ADDENDUM NO. 1

SOLAR PHOTOVOLTAIC ARRAY AT CITY HALL
CITY OF GALENA, ILLINOIS

Dated at Galena, Illinois
11 April 2016

1. SHEET NO. E6.1–32.5KW DC SYSTEM ONE-LINE DIAGRAM AND EQUIPMENT LAYOUT (PAGE 51 OF THE SPECIFICATION & BID PACKET)

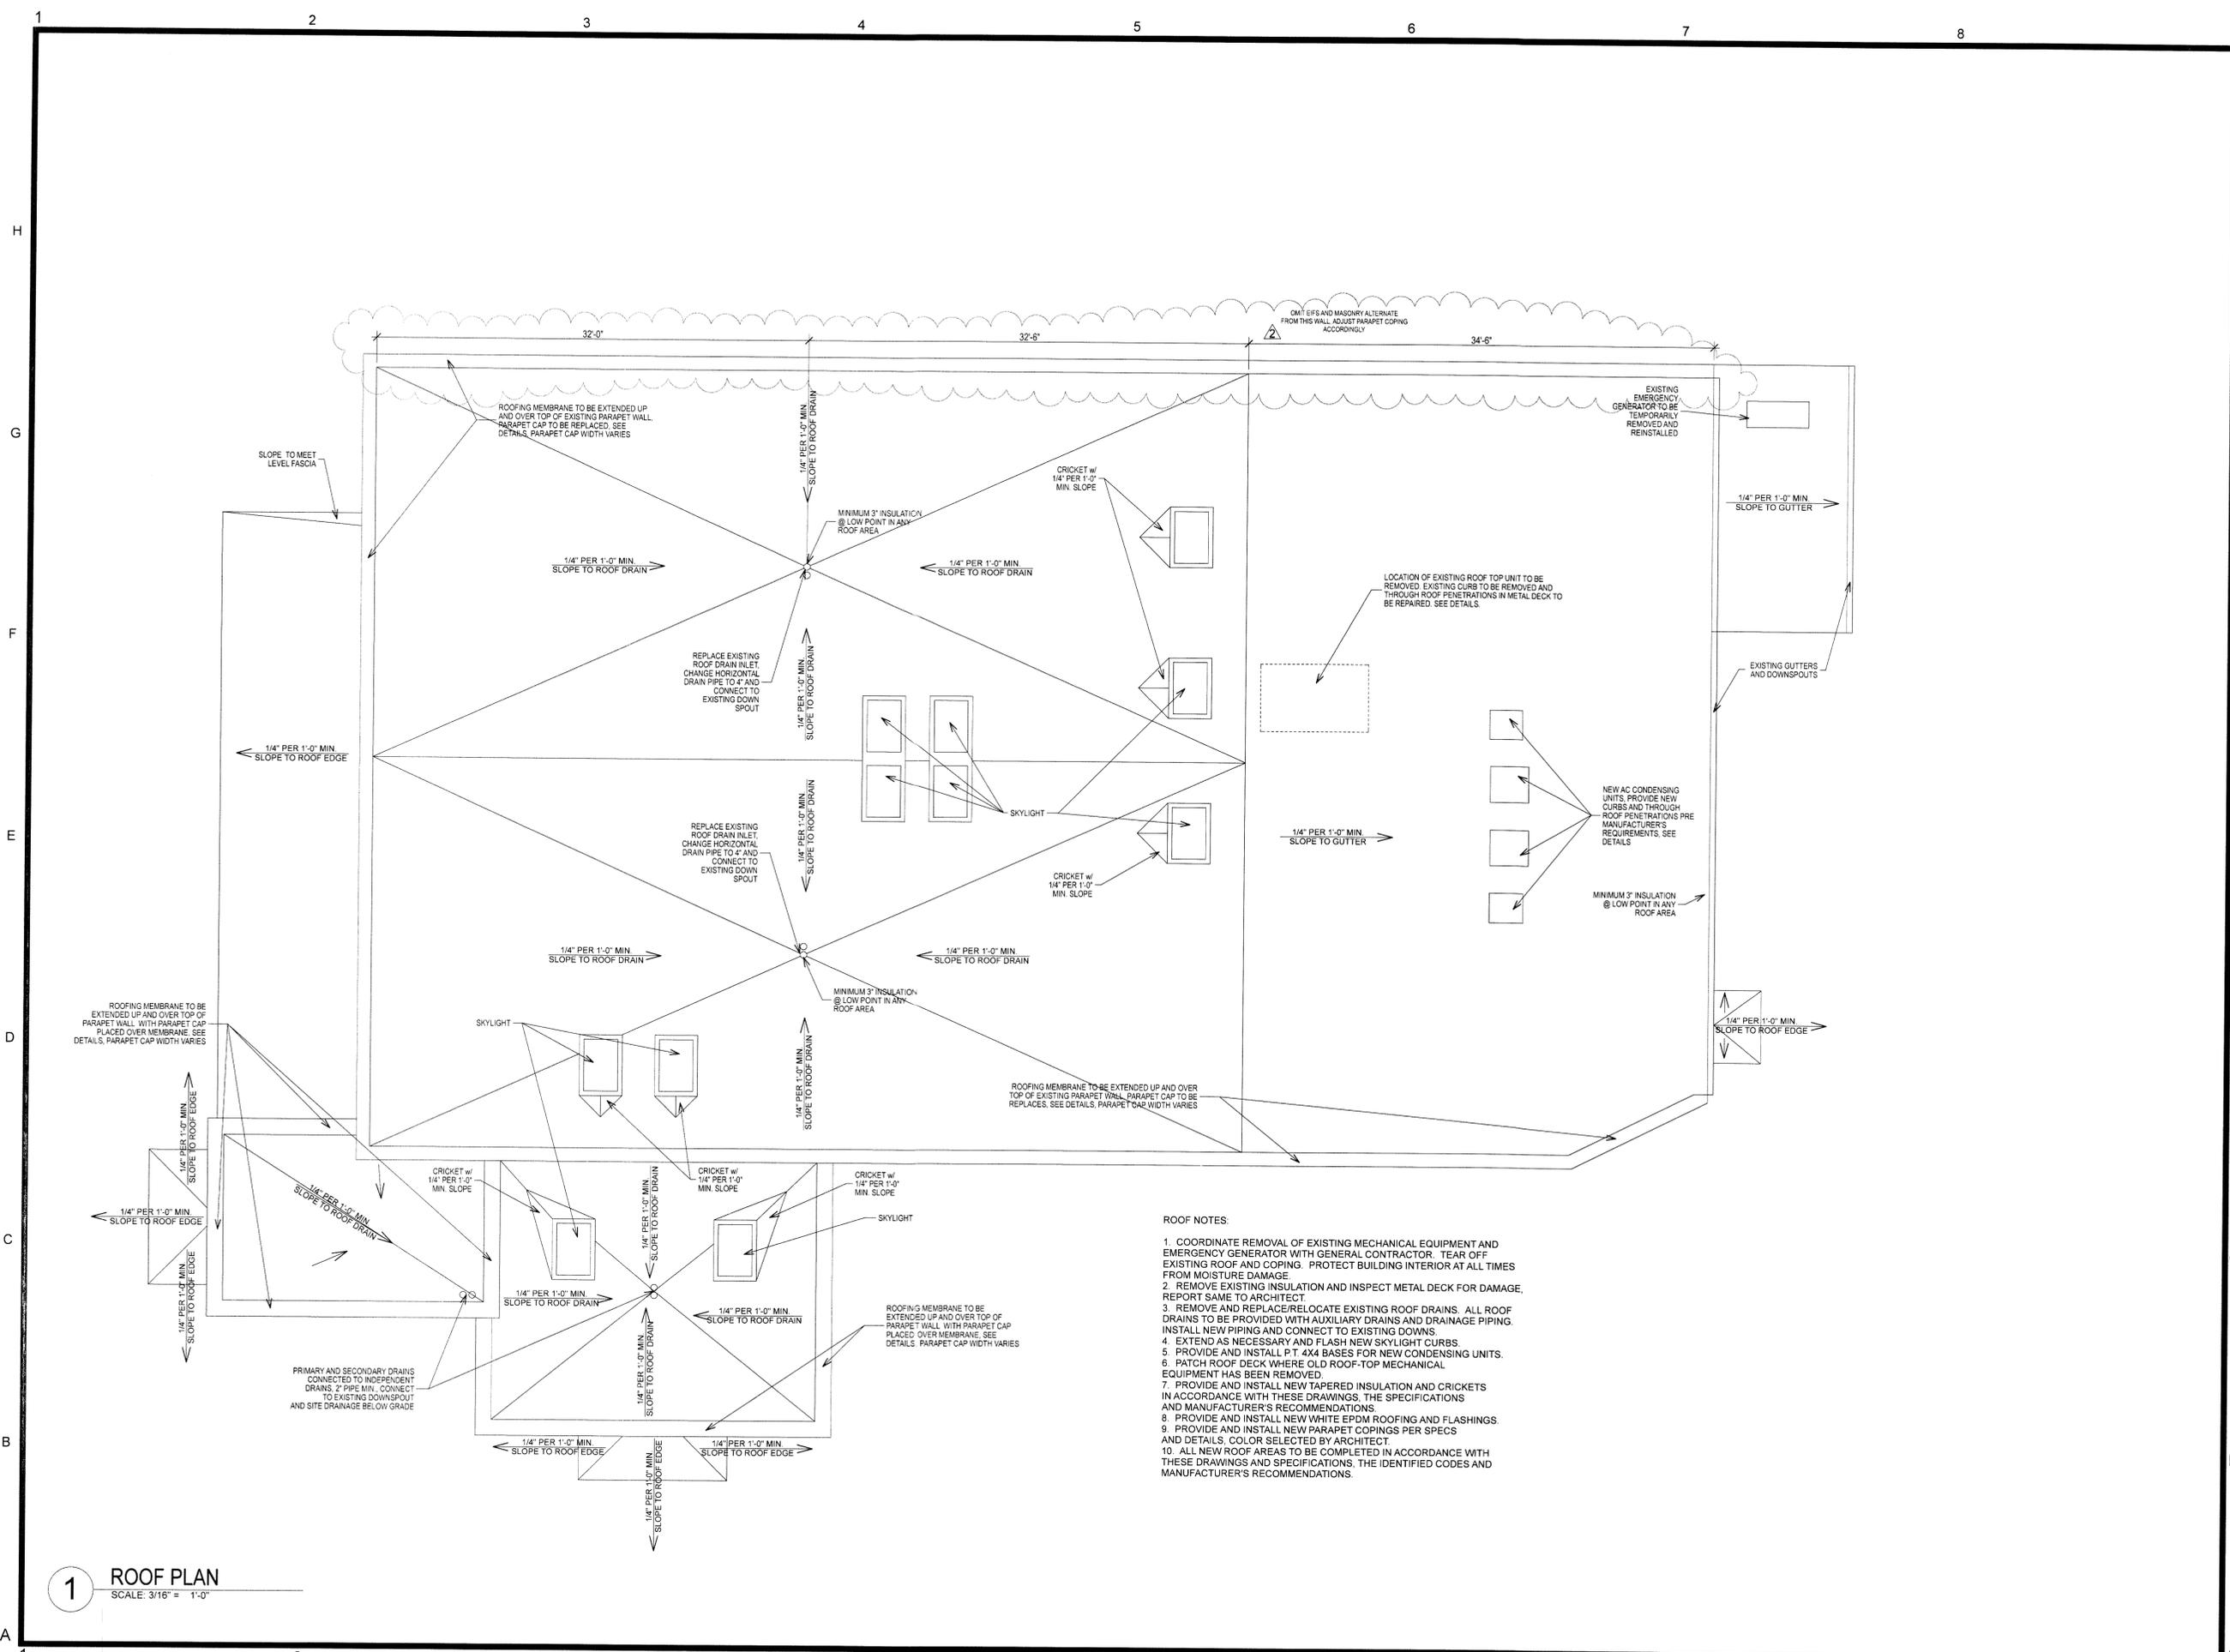
CHANGE the BATTERY STORAGE SYSTEM rating from 10 kWh to 7 kWh.

CLARIFICATION: The conductor sizes connected to the BATTERY STORAGE SYSTEM shall not change.
